Access Compliance Report

Public Rights-of-Way

(Pedestrian Signals)

Intersection ID: N/A	Main Street:	Cross Street: N/A	Location: N/A
ADA ID: AE371676C698	Signal Type: One Push Button-Non APS	Overall Compliance: No	Severity Score: BTN 1: N/A BTN 2: N/A No BTN: N/A
Codes/Mitigation Info/Possible Solution		Field Measurements/Component Compliance

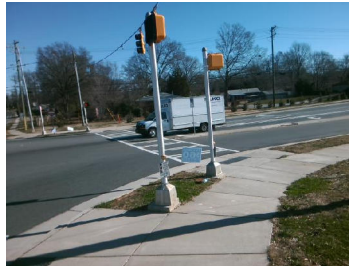
PROW/ADA: , TMUTCD 4e.08, R404.2, R406.2

Possible Solutions: Replace Signal Push Button With APS Button on New Post. Remove & Relocate Sign.
